Sydney Metro Martin Place

Sydney Metro and Over Station Development Design Review Panel #07

18 December 2018

Martin Place OSD DRP – Session 06 07.08.18:

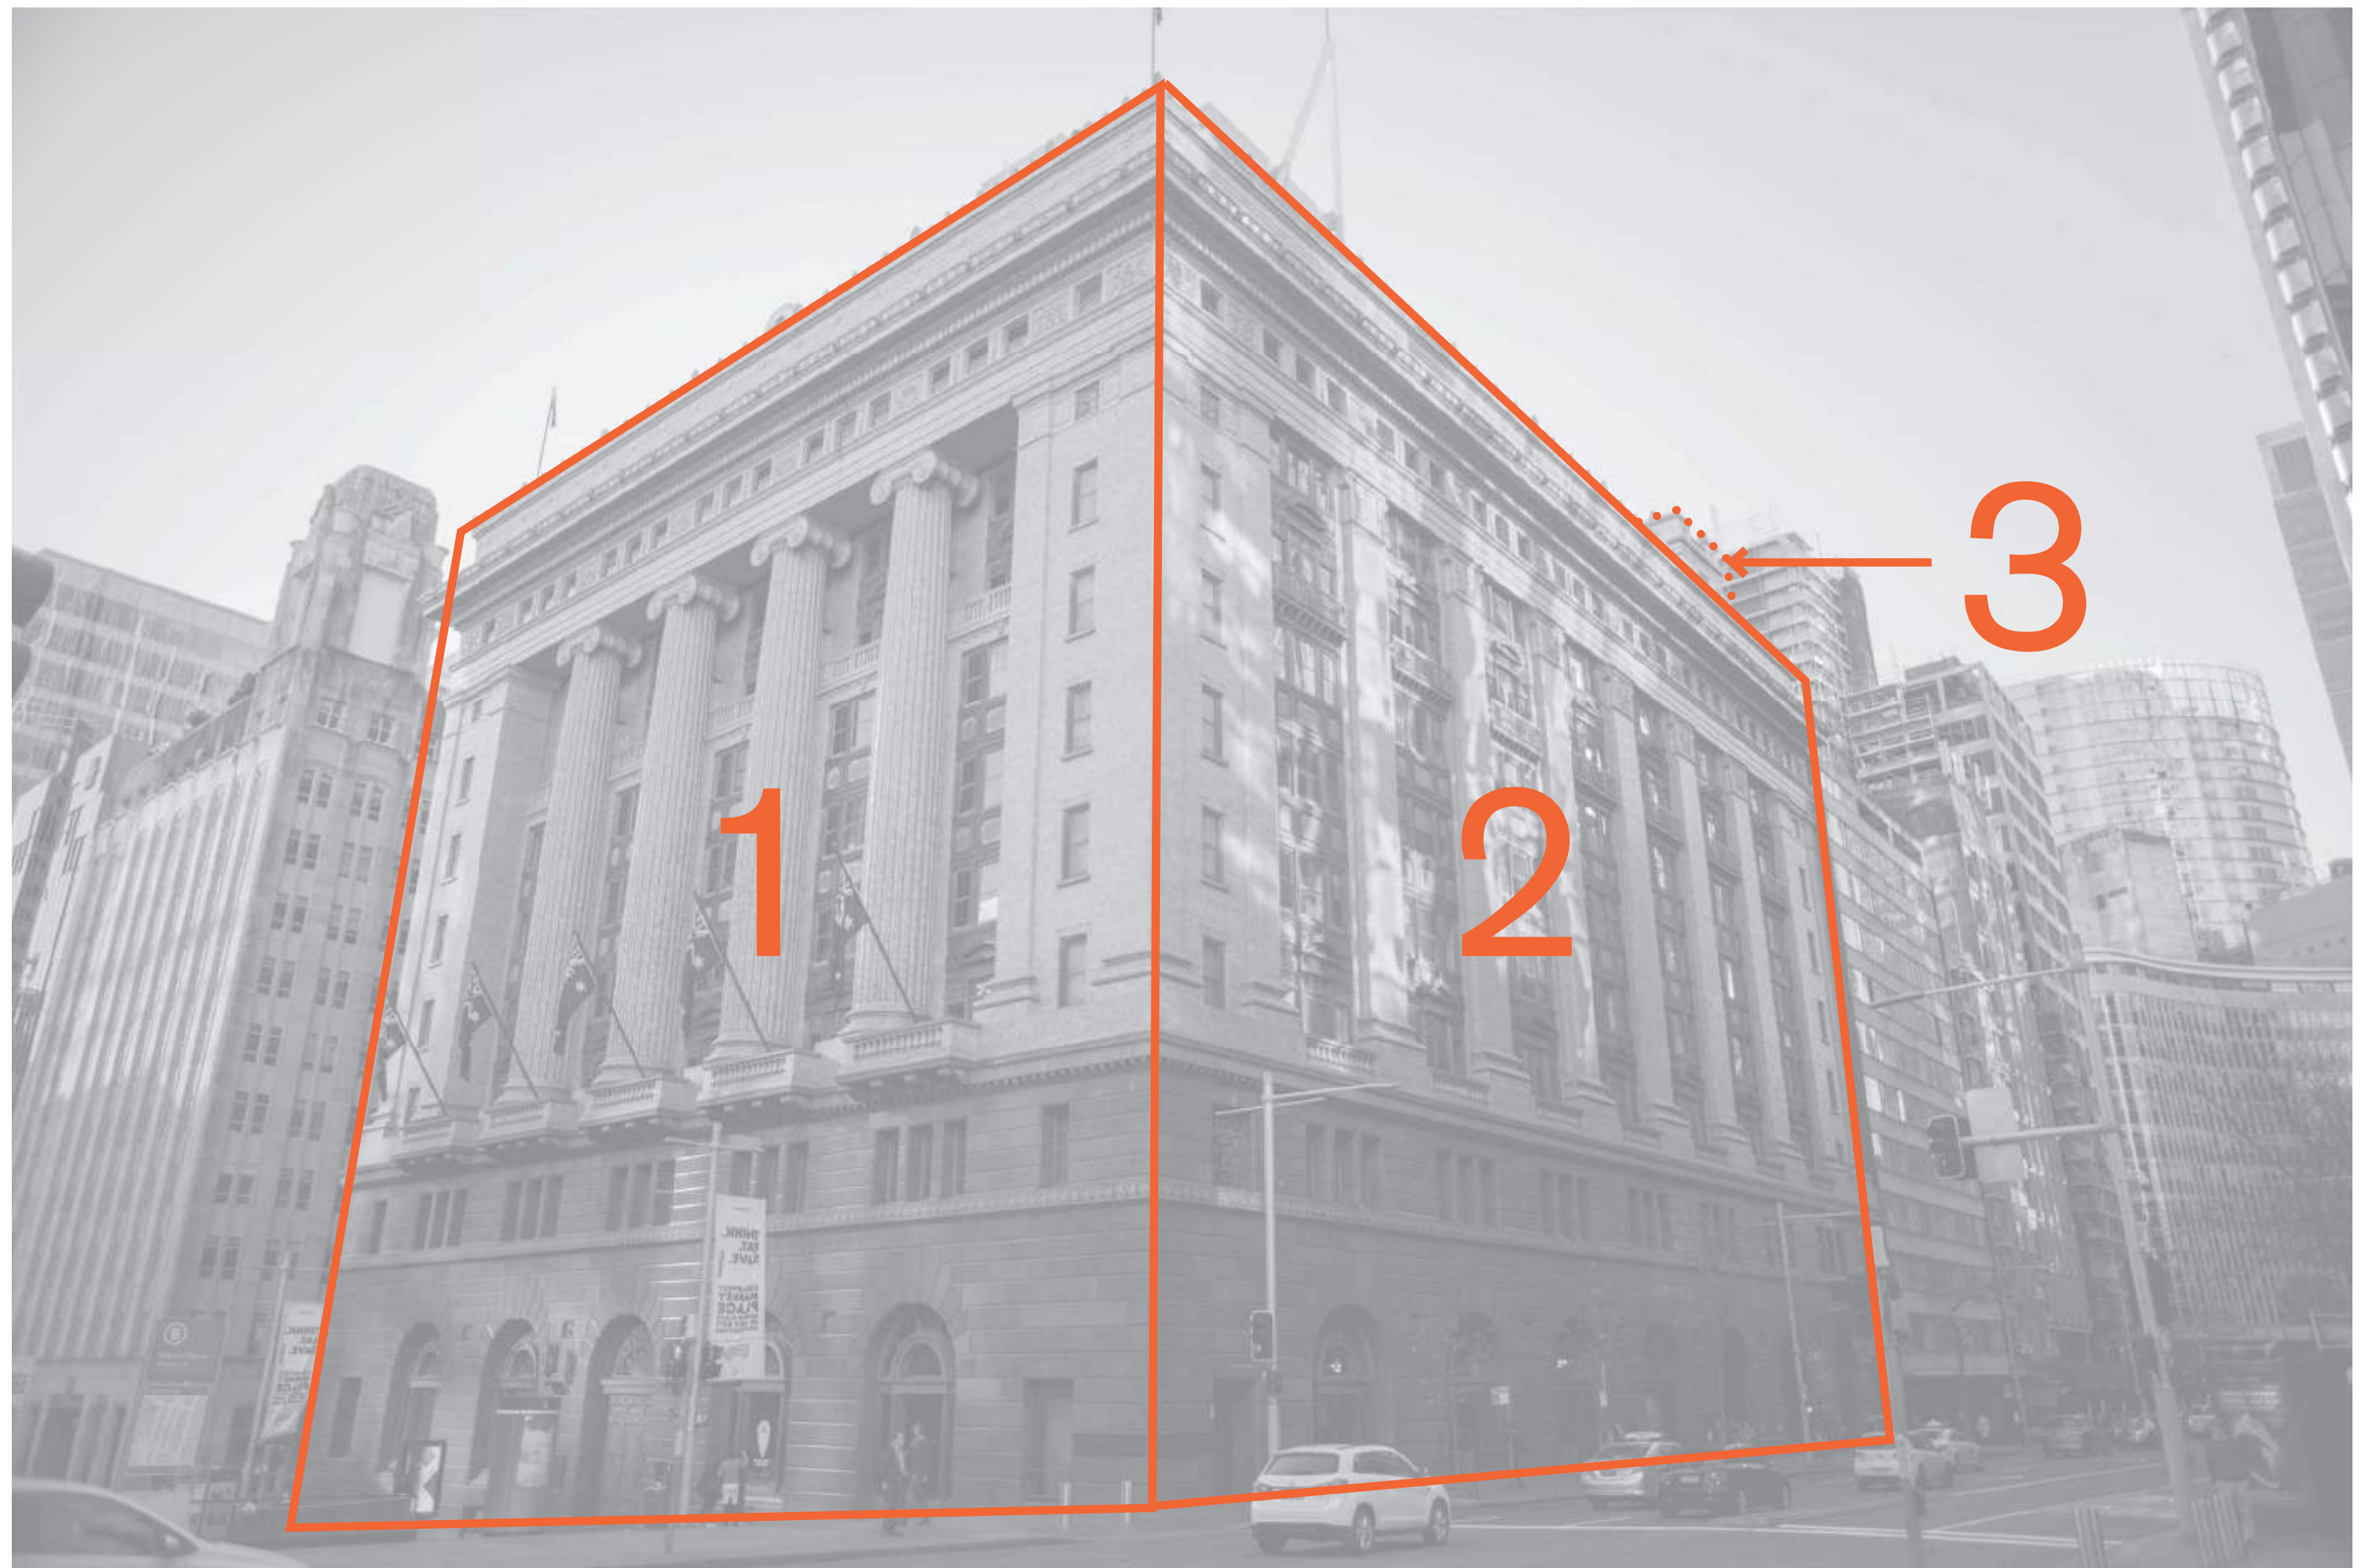
“We strongly recommend resolution of this [the south] façade in relation to the elevation as a whole, considering views from both Castlereagh and Elizabeth Streets.”

- amelioration of the negative impacts of the tall southern wall through articulation and texturing of this façade is to be included in the DA and presented for discussion at the next DRP; and
- tower floorplans be provided to understand building setbacks above the podium.
